Comments and Response Report

The Proposed Construction of an Access Road, Residential Dwelling on Portion 216 of the Farm Uitzicht, Brenton, Knysna

COMMENTS	RESPONSE
COMMENTS RECEIVED IN RESPONSE TO THE DRAFT BASIC ASSESSMENT REPORT – 3 September 2020 to 3 October 2020	
STATE DEPARTMENTS	
Forestry, Fisheries & The Environment (DFFE) – Melanie Koen – 30 September 2020

Site Development Plan

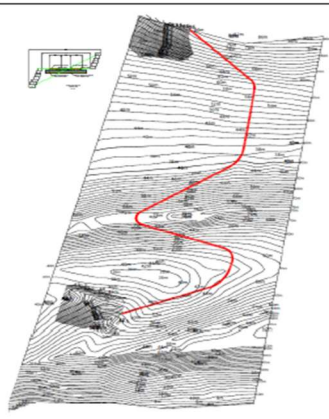
The road is proposed over 2 pristine dunes

Post fire Knysna Sand Fynbos in very good condition

Noted.

Proposed Site Development Plan with main house, road and managers cottage.

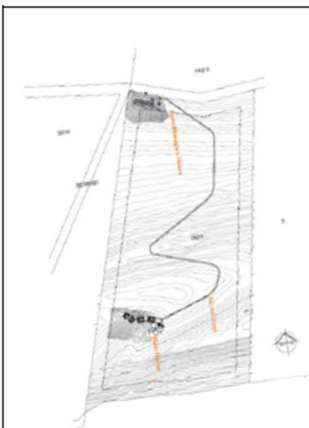
The proposed option to use the Campbell road will reduce the negative impact on biodiversity but will necessitate a new section of road to be constructed on the Campbell property and over Portion 76.

Noted. The preferred development plan has been amended to exclude the construction of a farm manager's residence in the northwestern corner of the property.

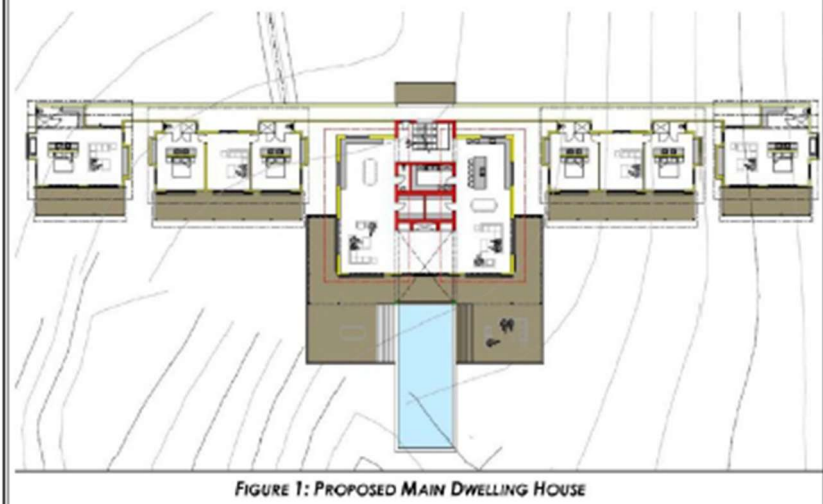
Development at Kerk Laan will have good views and limit disturbance of fynbos.

Development in the low lying area over the two sand dunes will compromise landscape functionality and set a bad precedent.

Figure 2 Residences (yellow circles) on Uitzicht properties are located adjacent to servitude roads (red and orange) to minimise internal access roads

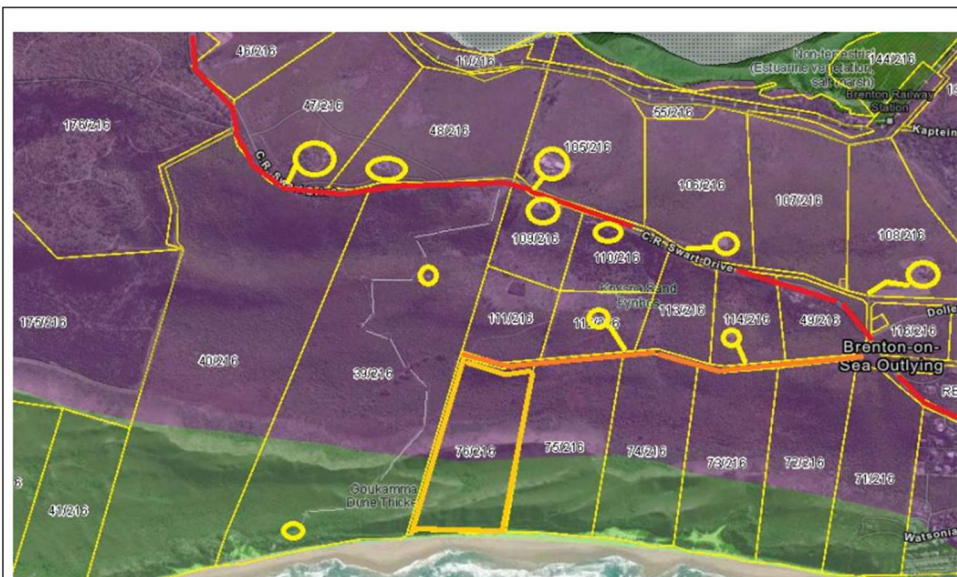
Location of existing Uitzicht residences in relation to servitude roads

Existing residences on all Uitzicht 216 properties are located as close as possible to municipal or provincial roads to prevent further fragmentation and disturbance by linear infrastructure such as internal roads (Fig. 2). The only exception (Uitzicht 216/39) has a historical road which was in existence when the current owners acquired the land in the early 1970s and runs along a registered public servitude that eventually leads to the coast. Uitzicht 216/39 (90 ha) also has a small dwelling close to the coast, which is a wooden structure between the primary and secondary dunes with an estimated disturbance footprint of 600 m². This dwelling is not visible from the beach, Buffalo Bay, Brenton on Sea, or any public roads.

Figure 3 – Architectural plan of the proposed main dwelling

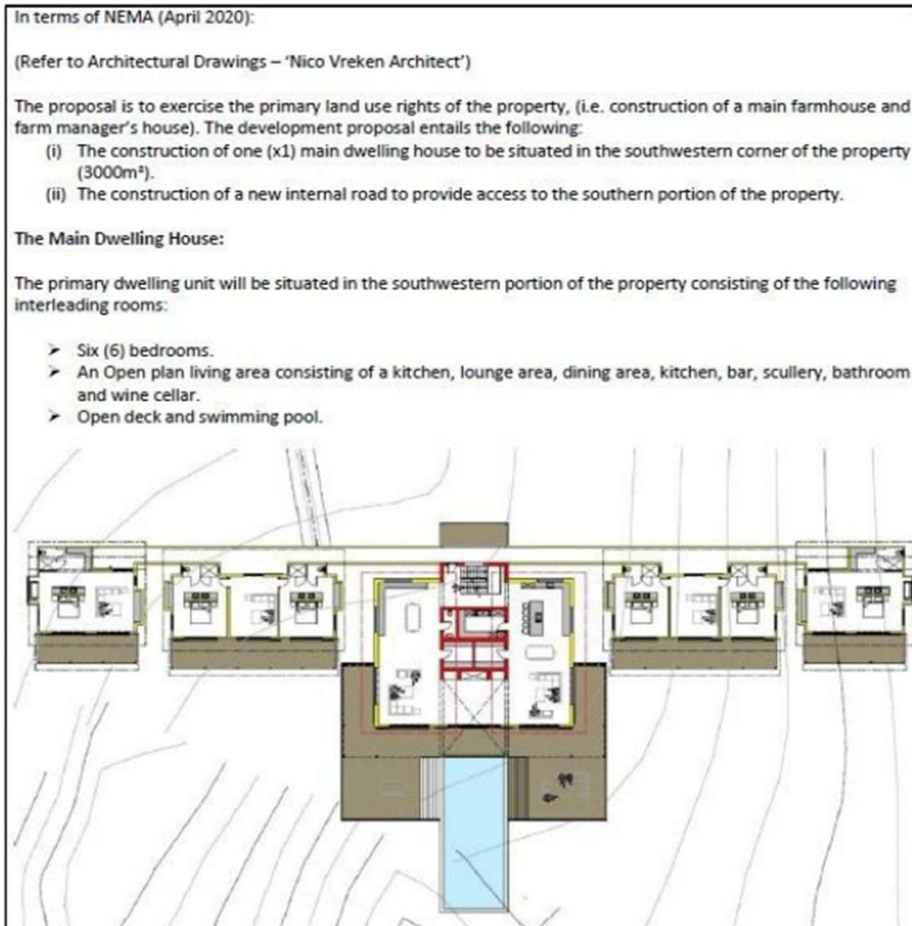
Only a basic floor plan of the preferred main dwelling proposed for the south-western corner of the site has been submitted for consideration (see Fig. 3 below), despite a reference to other architectural drawings. However,

there are no details pertaining to elevations, sections, 3D views, floor levels, or any external views from different angles. Reference is made to the approximately 3,000 m² disturbance area, without clarifying how much of this is building footprint, disturbance during construction, parking areas, water storage, utility areas sewerage disposal facilities, topsoil storage areas and so on. The floor plan in Fig. 3 has no scale and we can only guess that the main dwelling appears to be approximately 55m long and could be double or even triple storey.

The applicant acknowledges the comment regarding limited architectural detail in the DBAR. A basic conceptual floor plan for the main dwelling—

located in the south-western corner—has been provided at this stage, as the project is still in the environmental assessment phase. Full architectural details, including elevations, sections, and 3D views, will be submitted with the formal land use application to the Knysna Municipality, in line with statutory requirements and public participation.

Figure 5 – The vegetation of Uitzicht 76

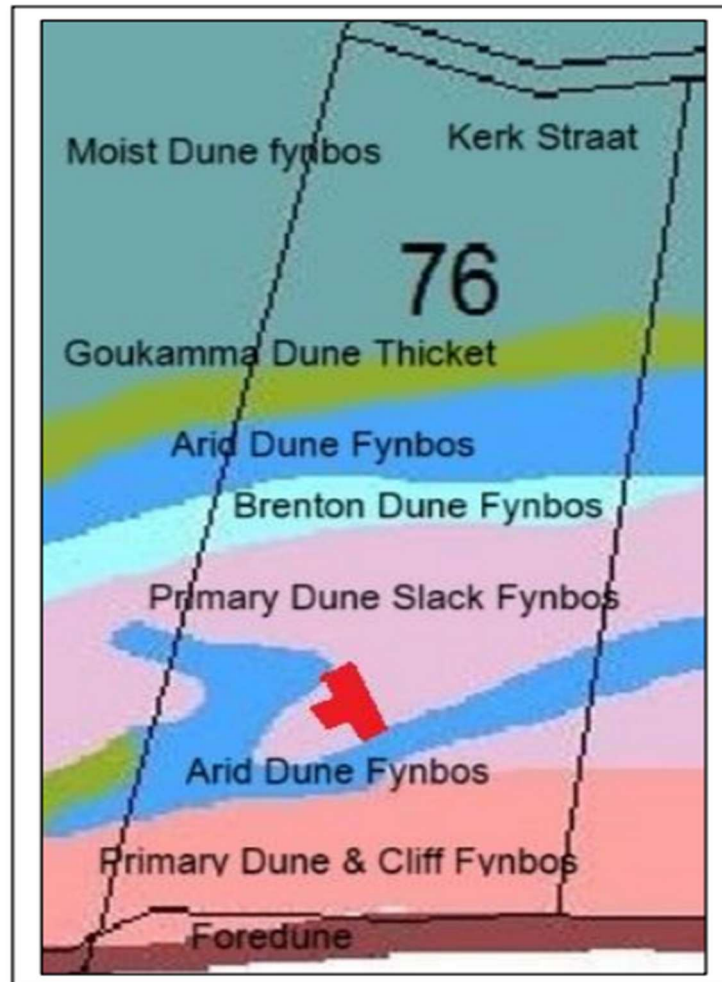
The Plant Species and Terrestrial Biodiversity Assessment (Fouché 2024) looked at the SANBI vegetation types (VEGMAP, 2018) but also at Vlok's vegetation types (2005) which are on a finer scale (see Fig. 5). Knysna Sand Fynbos (FFd10) is equivalent to Vlok's "Moist Dune Fynbos", which is south facing and moderately steep in places. Goukamma Dune Thicket (AT36), which Mucina & Rutherford had named South Cape Dune Fynbos (FFd11) in 2006, is only present as a thin strip in Vlok's vegetation mapping, found at the bottom of the primary dune. Higher up the dune this becomes Arid Dune Fynbos, which is north facing, very steep and sandy near the summit, and erodes easily if the vegetation is removed. The proposed "internal road" has to overcome this substantial obstacle. After the top of the dune it descends into south facing and gently sloping Brenton Dune Fynbos (BDF), a very rare vegetation sub-type poorly represented in the Goukamma Nature Reserve (GNR). In the shallow valley Primary Dune Slack Fynbos occurs, which is only found on the Brenton dunes and even scarcer than BDF. On this incredibly rare vegetation the applicant wants to build a 3000 m2 dwelling, which will be high enough to be seen from Buffalo Bay behind the highest primary

dune (with Arid Dune Fynbos). The steep, densely vegetated Primary Dune & Cliff Fynbos continues down to the Foredune.

Fouché (2024) found that the vegetation now mapped as Goukamma Dune Thicket contains a number of Red List plants and has a HIGH sensitivity ecologically. From an environmental perspective it would be difficult to find a place less suited to building a house.

Figure 5 – The three alternatives assessed in the DBAR – Alternative 4, the least environmentally damaging, was not considered

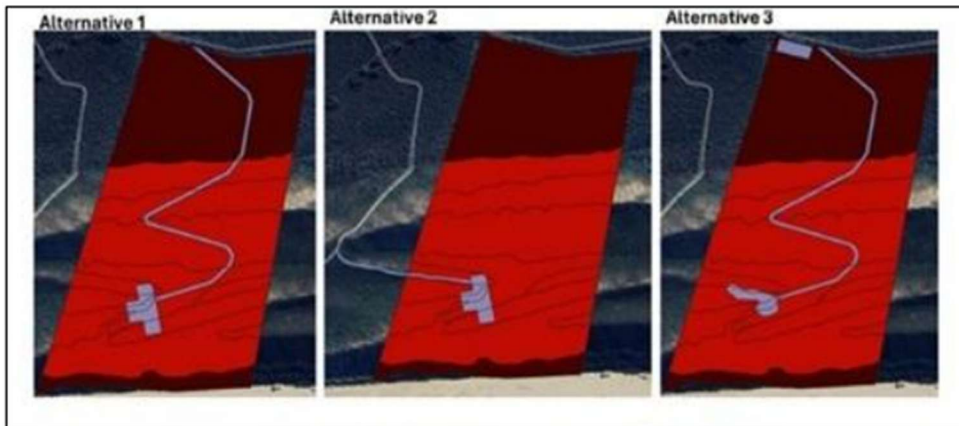
The DBAR Illogically selects the worst two Alternatives (1 & 3 ref BAR page 76) contrary to the conclusion that Alternative 4 is the best as per Page 77 and ignores the fact that an internal road is not allowed under the WCLUPGRA 2019 guidelines pertaining to Core 1 SPC. The applicant needs to be interrogated as to why Alternative 4 (Fig. 6) is not being considered, and Alternative 1 is the preferred option.

The proposed development on Portion 76/216 will affect sensitive fynbos and strandveld vegetation within a Critical Biodiversity Area 1 (CBA 1). The impact assessment recommends Alternative 4 as the best layout, with Alternative 2 also being viable. Both result in Minor or Negligible impacts, while Alternatives 1 and 3 risk requiring offsets due to Moderate impacts. Alternative 4 is preferable because it minimizes project footprint, reduces fire risk, limits landscape fragmentation, and results in less than 1% transformation of the property, compared to over 2% for other options.
